South Texas Project
Units 3 and 4
Docket Nos. 52-012 and 52-013
Response to Requests for Additional Information

Attached are responses to NRC staff questions included in Request for Additional Information (RAI) letter numbers 236 and 237 related to Combined License Application (COLA) Part 2, Tier 2 Appendix 6C.

RAI 06.02.02-14:**QUESTION:**

Figure 6C-1 Cassette Strainer Cutaway

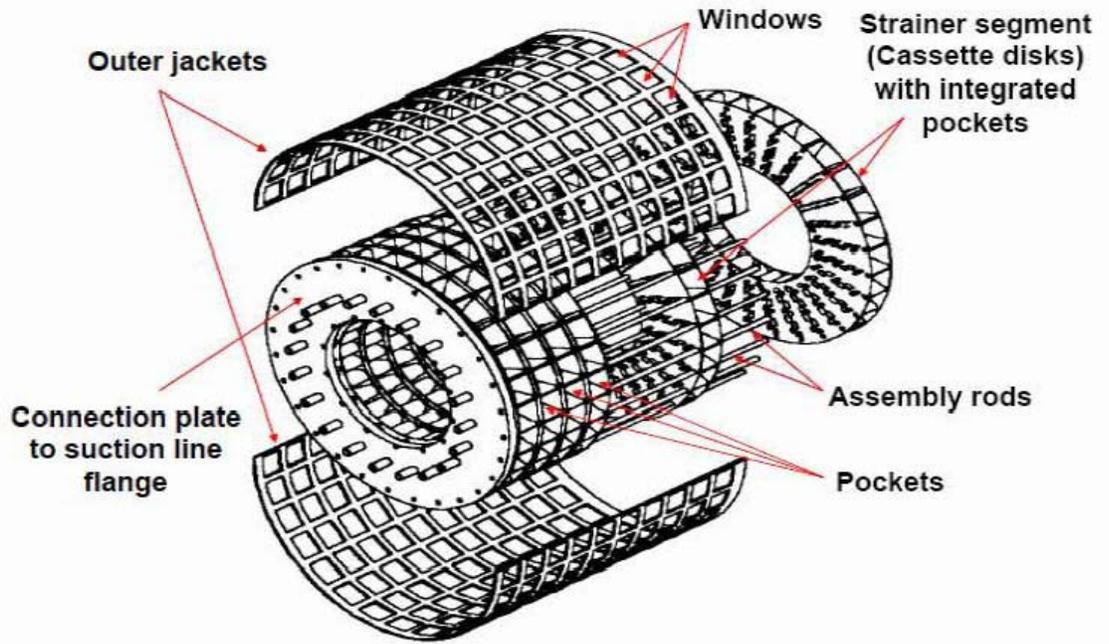
In its RAI 06.02.02-6 Supplemental Response, dated October 29, 2009, the applicant proposed a change to the STP 3&4 FSAR that “The ECCS suction strainer design to be used on STP 3&4 is the same as the design for the Reference Japanese ABWR.” (page 4 of 247)

The applicant should provide sufficient information in the FSAR on the strainers rather than referring to a plant for which information is not readily available.

The basic design of the STP 3 & 4 suction strainer, which is the same as that for the Reference Japanese plant, is a cassette-type strainer that is described in the text and associated references in Appendix 6C to Part 2, Tier 2 of the STP 3 & 4 COLA. That section also provides the criteria to be used for sizing of the suction strainer. As noted in the response to RAI 06.02.02-6 (RAI 2042 Supplement 1), the STP 3 & 4 strainers will be at least as large as the strainers for the Reference Japanese ABWR ECC systems.

As requested by this RAI, this response provides additional suction strainer design details as a revision to the COLA. The FSAR markup previously provided on October 29, 2009 in Letter Number U7-C-STP-NRC-090179 (page 4 of 247) will be revised by replacing the markup of Section 6C.5.1 with the one below. In addition, Section 6C.2 will be revised as shown below to provide additional design details of the strainer. Section 6C.6 is updated to add the three references which are described in the markup to Section 6C.5.1. Changes from COLA Rev. 3 are highlighted with gray shading.

The ECCS suction strainer design to be used on STP 3&4, which is described in the STP 3 & 4 FSAR Appendix 6C.2 and its associated references, is the same as the design for the Reference Japanese ABWR (see References 6C-11, 6C-12 and 6C-13), and the STP 3 & 4 strainers will be at least as large as the Reference Japanese ABWR strainers. Application of the Reference Japanese ABWR ECCS suction strainer design to STP 3&4 is conservative for the following reasons:
